**1.0 APPLICATION SUMMARY**

**Applicant:** Hung T. Mai  
**FLU Category:** R-4  
**Service Area:** Urban  
**Site Acreage:** 9.58  
**Community Plan Area:** Greater Carrollwood Northdale  
**Overlay:** None  
**Request:** To allow development of 3 single family lots/detached units

**APPLICATION NUMBER: PRS 22-0501**

## AGENCY REVIEW COMMENT SHEET

2.3 Proposed Site Plan – General Site Plan – (partial provided below for size and orientation purposes. See Section 8.2 for full site plan)

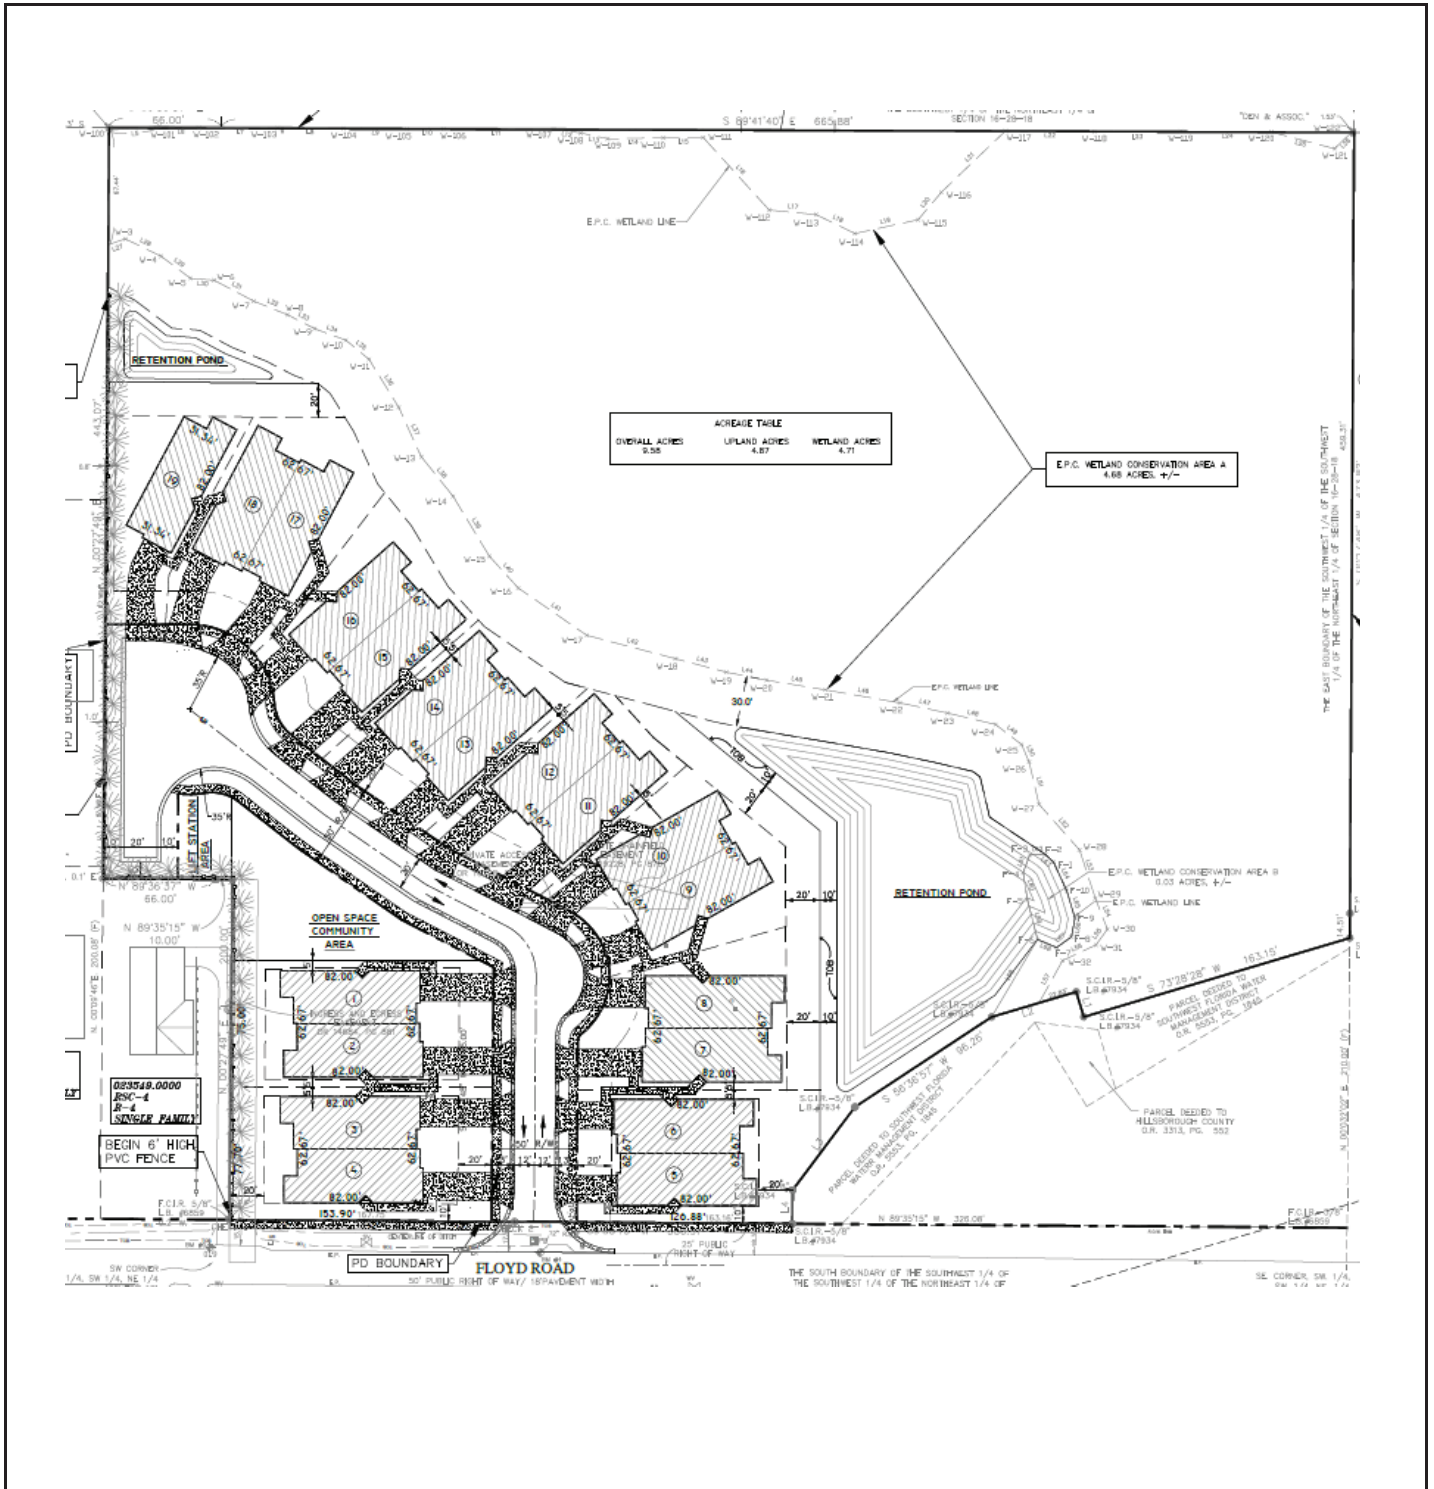
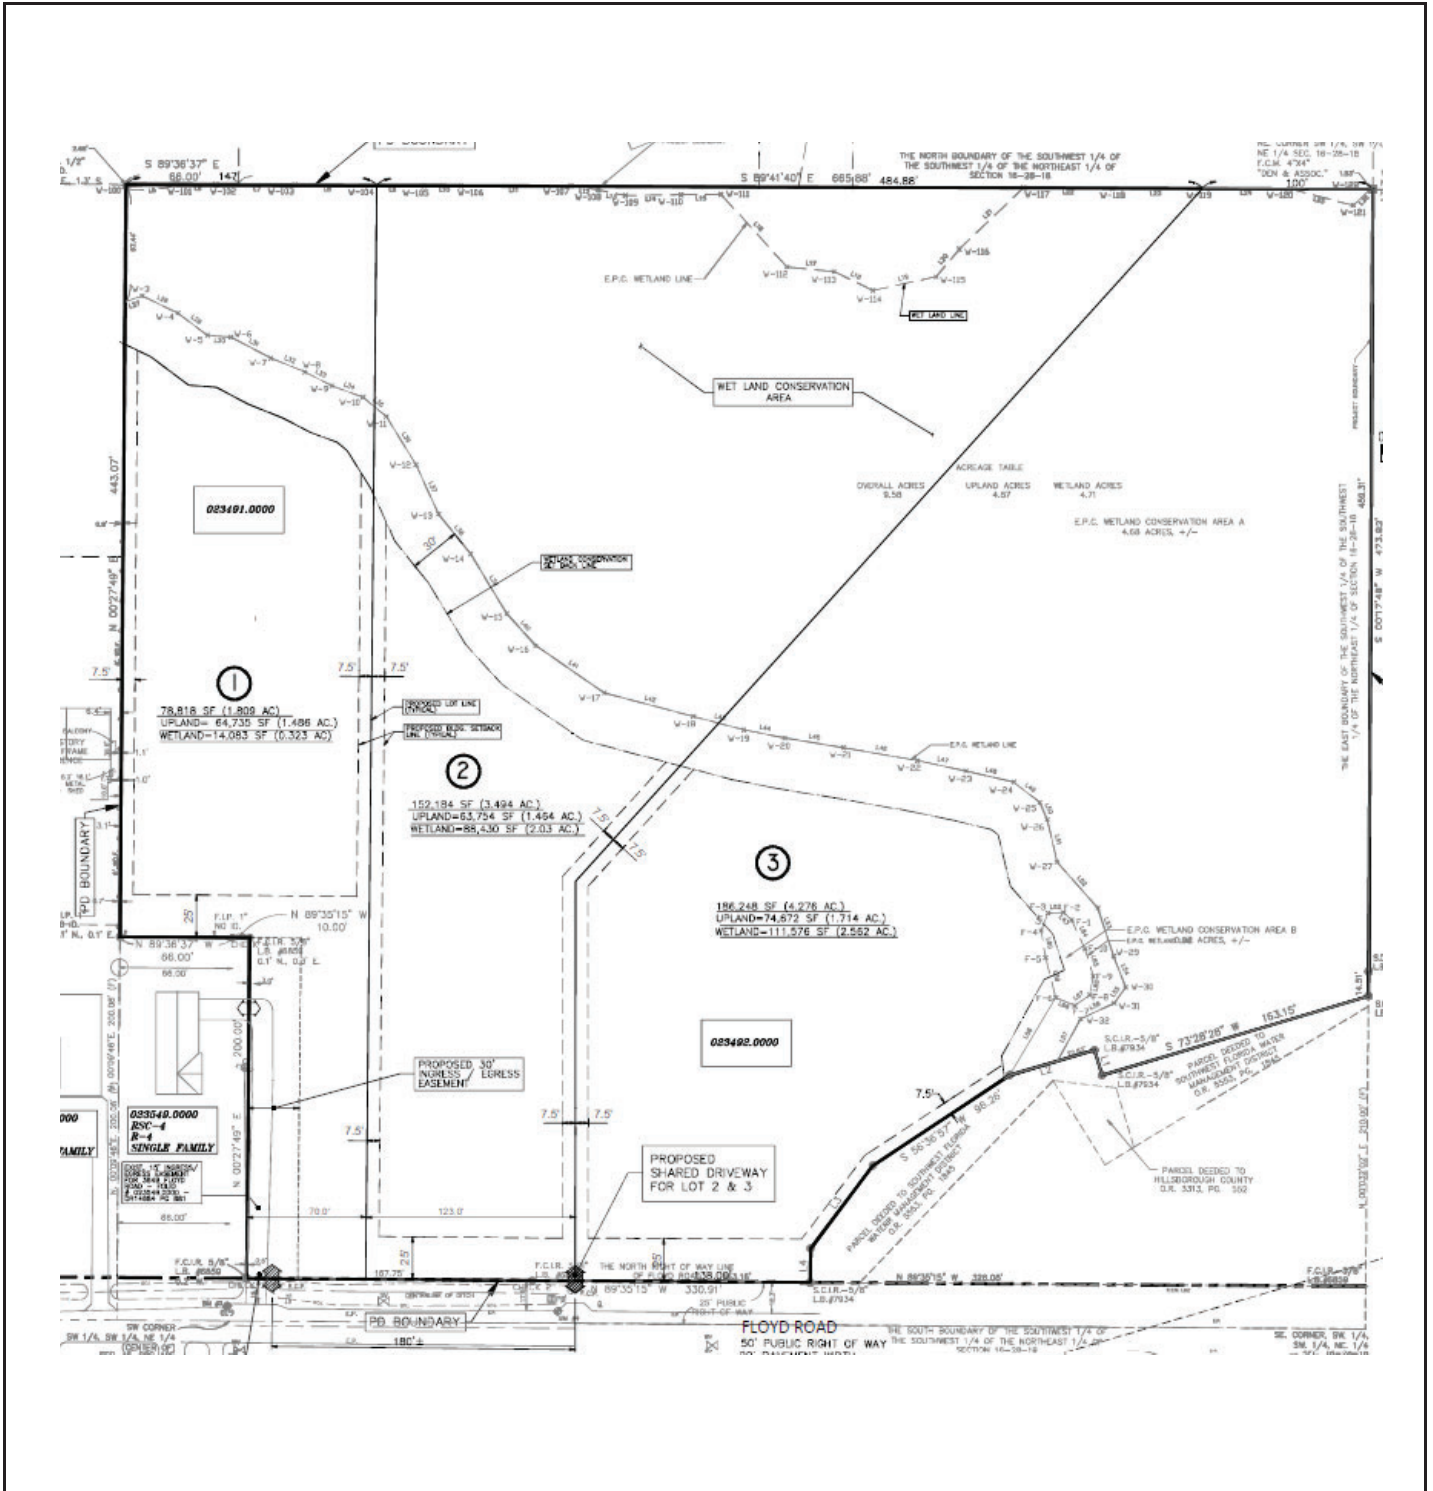
The applicant proposes to modify the PD to allow up to 3 single family lots to allow detached homes. An existing access easement along the west will remain to serve as access from Floyd Rd. to the adjacent property to the west (pre the recorded easement) and to one of the proposed lots (Lot 1). A second driveway connection will serve the two remaining lots, as a shared access facility. The lots will be developed with RSC-4 setback standards. However, the proposed minimum lot width for Lot 1 will be 55 feet along its frontage. The area of the proposed lots (over 1 acre of upland) would be more than the RSC-4 lot size established by the LDC (10,000 sq. ft.). The subject site has extensive wetlands, however, no impacts to wetlands are proposed, and setbacks will be maintained as required by the LDC. Buffering and screening along PD boundaries will be eliminated since the proposed project consisting of 3 single family lots is not required to provide these. Additionally, the requirement to provide community gathering space will be removed since the proposed project will not be required to provide this space due to the low residential scale.

The proposed changes do not alter the integrity of the existing PD. The PD currently allows residential units, including detached. Development of the project with 3 detached residential homes would be less dense than the currently approved density.

Transportation staff reviewed the request and does not object. Conditions are proposed governing the provision of the shared access facility for the proposed lots. Additionally, the applicant submitted an Administrative Variance to reduce the spacing of the driveway on a collector road and has been found approvable.

In conclusion, the proposed three lots with two access points along Floyd Rd. is compatible with the scale of the nearby development pattern. Single family lots with detached units zoned RSC-4 and RSC-6 are much prevalent in the area compared to duplexes or attached units. The proposed development standards will be consistent with the standards found in nearby lots. The project will be subject to subdivision regulations, and will connect to water and sewer per the Land Development Code requirements.

**APPROVAL**- Approval of the request, subject to the conditions listed below, is based on the general site plan submitted ~~December 22, 2020~~ March 14, 2022.

1. The project shall be developed with a maximum of ~~19~~ 3 single-family ~~detached residential units (9 duplexes and 1 detached unit).~~ Existing single-family residential uses shall be permitted until the site is developed with the ~~duplex~~ 3-lot project.

~~63.~~ The site shall be allowed ~~one~~ two access connection on Floyd Road.

~~4.~~ If PRS 22-0501 is approved, the County Engineer will approve the Section 6.04.02.B. Administrative Variance (dated March 28, 2022), which was found approvable on March 29, 2022. Approval of this Administrative Variance will permit reduction of the minimum access spacing between the proposed new driveway and the existing on-site access easement/driveway to +/-180 feet; and between the existing on-site access easement/driveway and five (5) existing offsite driveways to its west to the following respective distances: +/-30 ft, +/-60ft, +/-90ft, +/-130ft, +/-165ft.

# EXHIBIT A: SWEETWATER FLOODPLAIN

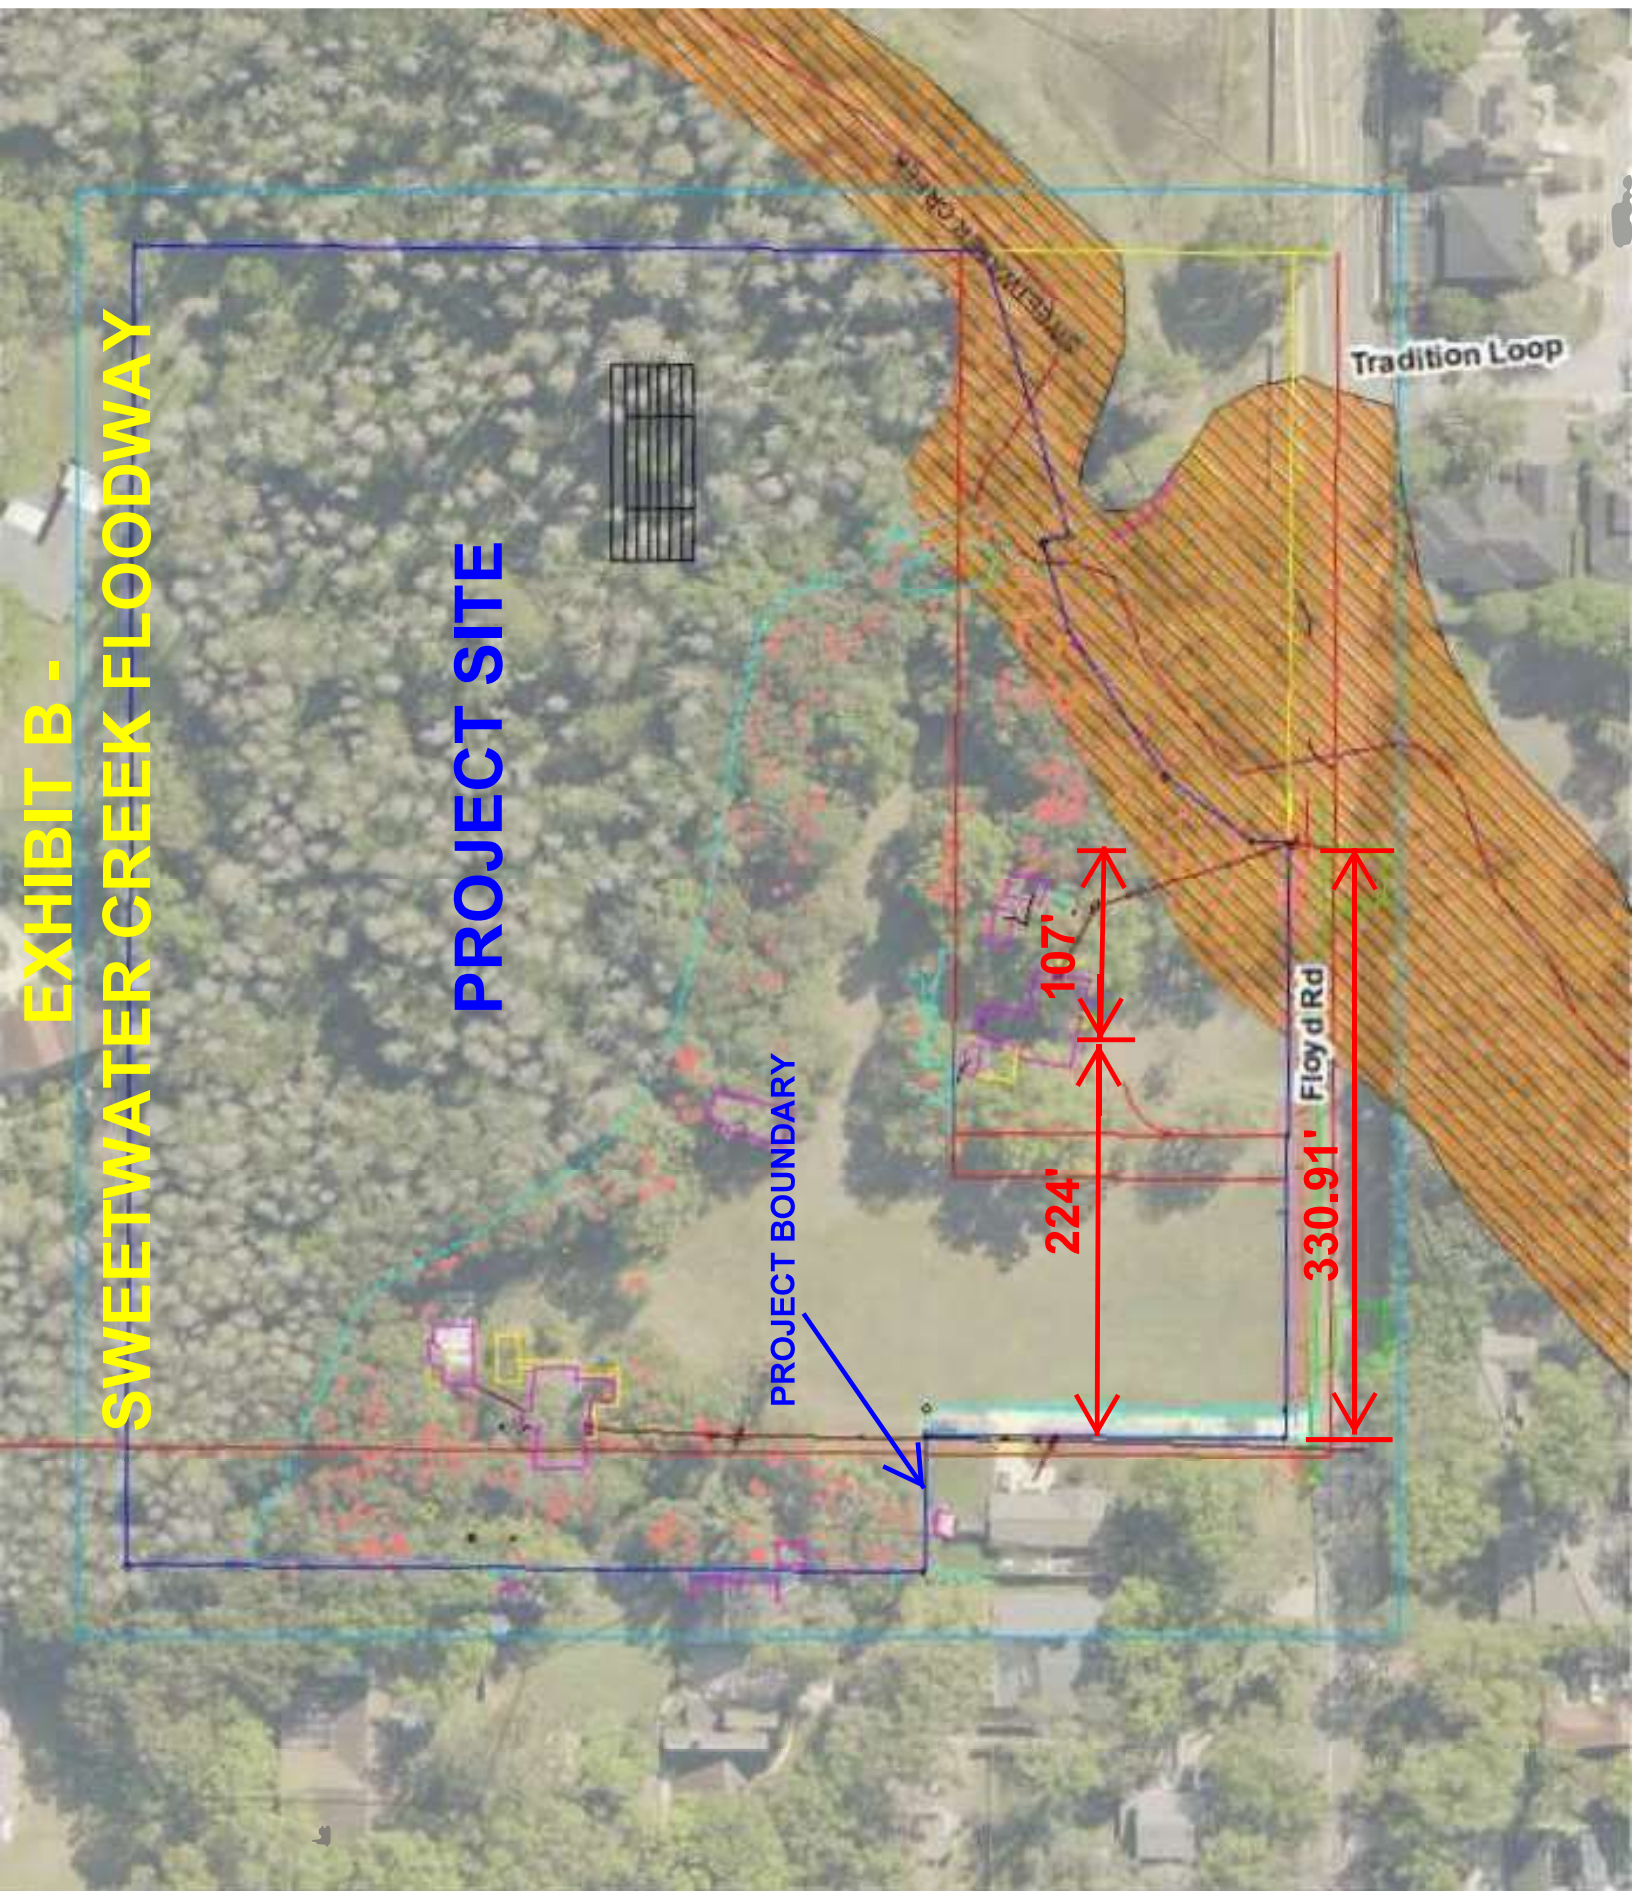
- The subject property is adjacent to the Sweetwater Creek which is sloping floodplain (**EXHIBIT A**). The project's eastern access is adjacent to Sweetwater Creek's floodway and encroaches into the front of the property along Floyd Road (**EXHIBIT C**). There is about 224 feet between the two proposed access points while trying to avoid the floodway area and a shared access will be proposed for Lots 2 and 3 in order to minimize access connection along the collector road. Achieving the minimum required spacing of 245 feet will become a burden to the applicant due to the grading difficulties and possible environmental impacts.

**EXHIBIT B -  
SWEETWATER CREEK FLOODWAY**

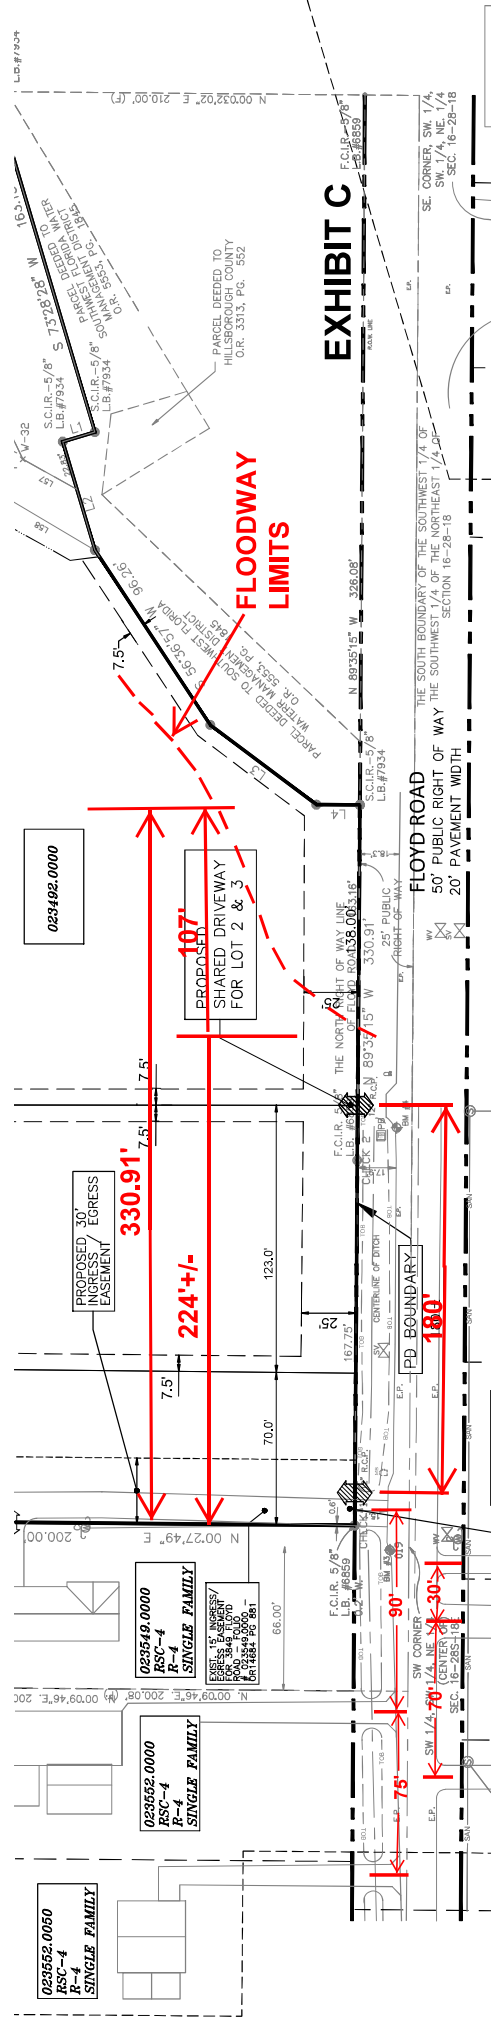
- A portion of the subject parcel was deeded to the Southwest Florida Water Management District (SWFWMD) recorded in OR 5553, Page 1845. In addition, a portion of the subject parcel was deeded to Hillsborough County recorded in OR 3313, Page 552. Proposing a driveway further east on the subject site to provide additional spacing is impossible due to the deeding and filling the floodway is prohibited not to mention unjustifiable with FEMA (**EXHIBIT B**). Thus, this creates an unreasonable burden on the applicant.
